REGULATORY INFORMATION DISTRIBUTION SYSTEM (RIDS)

SUBJECT: Responds to NRC 920702 ltr re violations noted in Insp Rept 50-305/92-07 on 920309-13. Corrective actions:util allocating equivalent of three full-time engineers for operational experience assessment evaluation for remainder of 1992.

Docket 50-305
Operating License DPR-43
Kewaunee Nuclear Power Plant
Response to Inspection Report 50-305/92007 (DRP)

OEA TREND DATA

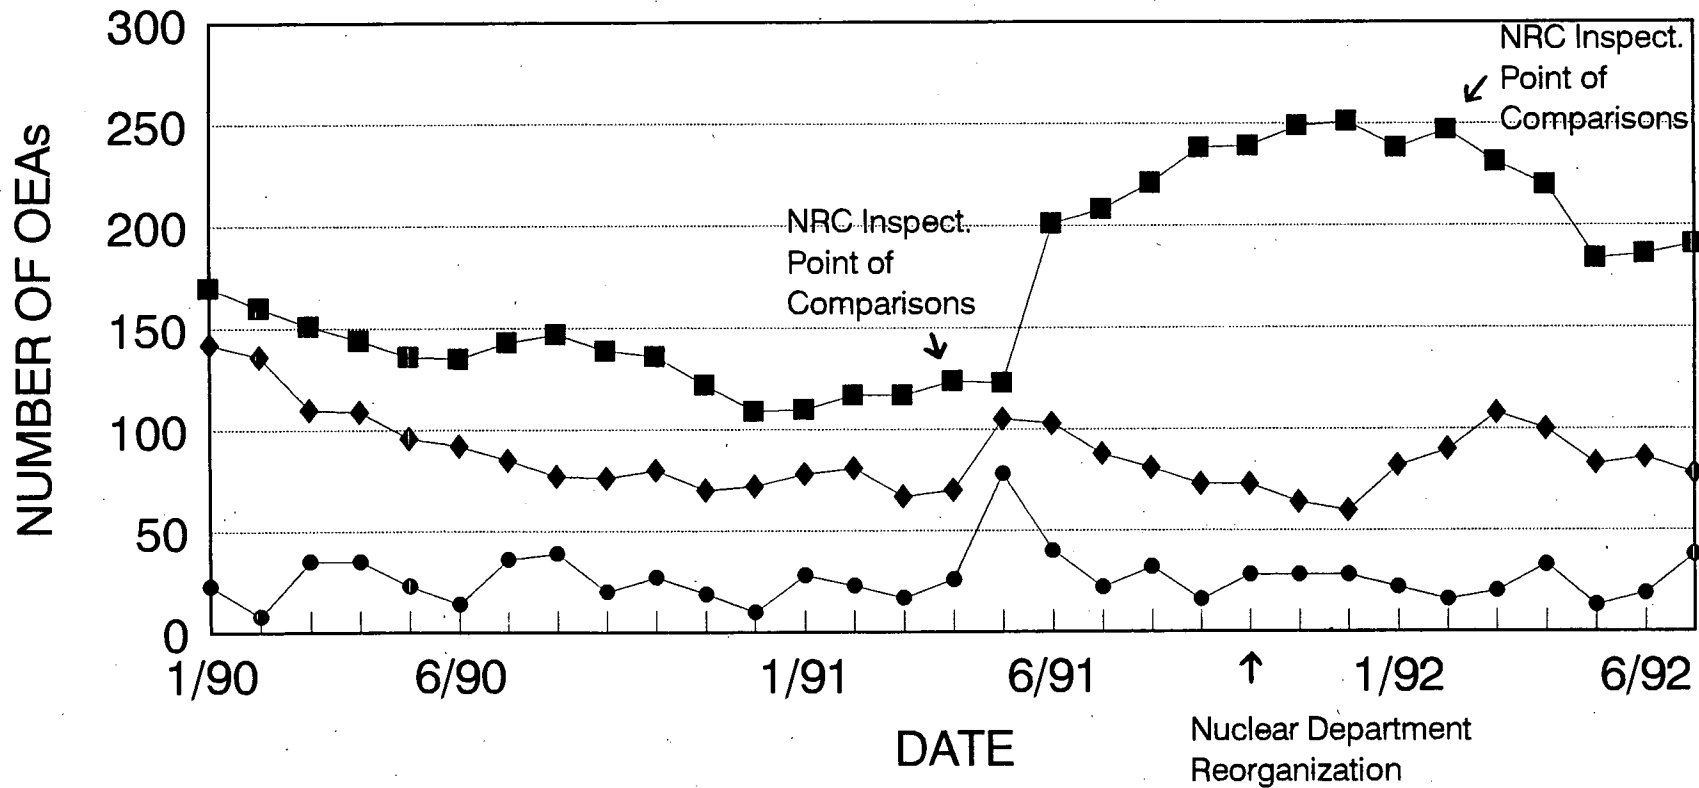
The inspector found the OEA program was a strength as written but had implementation weaknesses. The current backlog has existed for an excessively long time. This failure to effectively implement the program is an open item (50-305/92007-01).

The inspection report also noted a concern that the backlog of OEA's awaiting evaluation could prevent timely identification of issues of potential safety significance. We believe the programmatic aspects of our OEA program (which were noted to be a strength by the inspector) are sufficient for ensuring that safety significant issues are identified and addressed in a timely manner. These programmatic controls include a screening process of incoming reports which specifically considers the safety significance of the report. If the report is identified to be safety significant, the program provides for prioritization of evaluation and disposition of the concerns.

In order to put the OEA backlog comparison used in the inspection in perspective, a trend of the OEA evaluation backlog from January, 1990 through July, 1992 was prepared (reference attachment 2). WPSC believes this trend more clearly depicts the past and present OEA evaluation status. An increase in the backlog occurred in 1991. The 1991 increase is attributed

- to:
- 1) 61 OEA's being generated in May, 1991 on the electrical/mechanical diesel generators due to technical manual updates resulting from the Vendor Technical Information Program (VTIP).
 - 2) In March 1991, the transfer of OEA evaluations from contractors to in-house engineering resulted in a loss of efficiency due to project turnover.
 - 3) The impact of the October, 1991 WPSC Nuclear department reorganization and the subsequent short term reprioritization of the newly formed Nuclear Engineering Support Group on outage modification projects for the March, 1992 refueling outage.

The positive aspects of the Nuclear department reorganization along with the OEA resource allocation increase can be observed by the reduction in the backlog since April, 1992. WPSC intends to continue committing the resources necessary to decrease the OEA backlog. We believe that the information provided in this letter and the actions taken to decrease the backlog of OEA's adequately address your concerns.
